Genesis Care Campbelltown NSW (2036/2021/DA-C)

RESPONSE TO COUNCIL RFI - STORMWATER

Figure 1 Narellan Road Drainage Mechanism

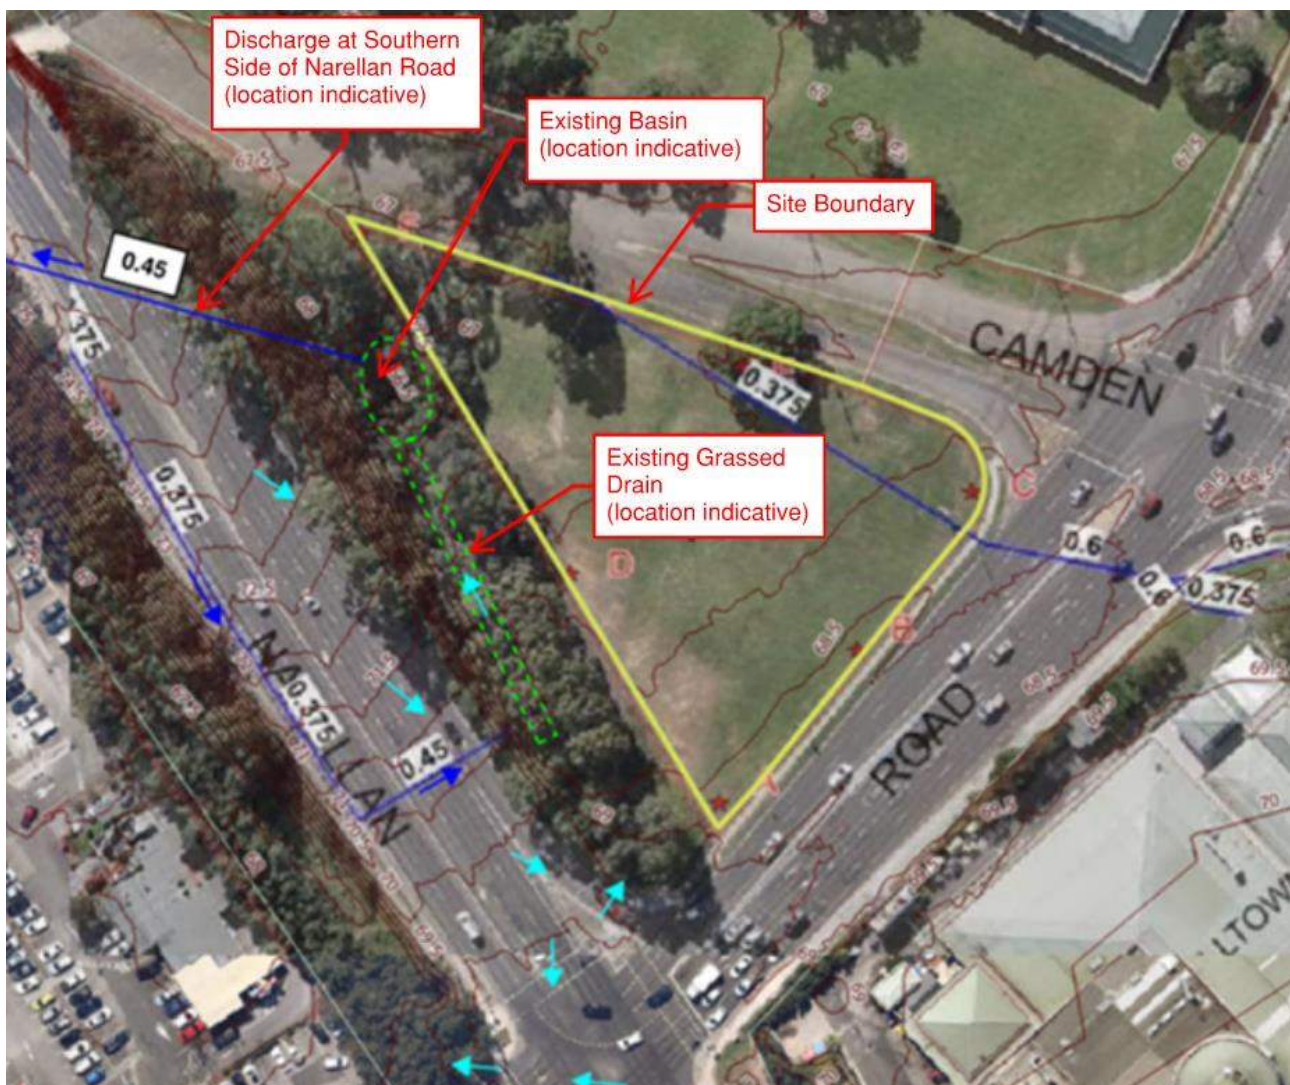
(d) The existing stormwater line from Narellan Rd is to be connected to the stormwater network.

- We understand that the Narellan Road drainage network is under the TfNSW administration.
- Based on the Narellan Road drainage plan (TfNSW) provided by Council, the existing drainage system consists of a grassed open drain along the northern embankment of Narellan Road followed by a sedimentation basin. The basin receives stormwater flows from Narellan Road (for an extent between Narellan Bridge to intersection of Narellan Road and Kellicar Road) via an existing 450mm pipe. The basin drains towards the Birunji Creek Culvert at southern side of Narellan Road via an existing 450mm drainage pipe (Refer Figure 1).
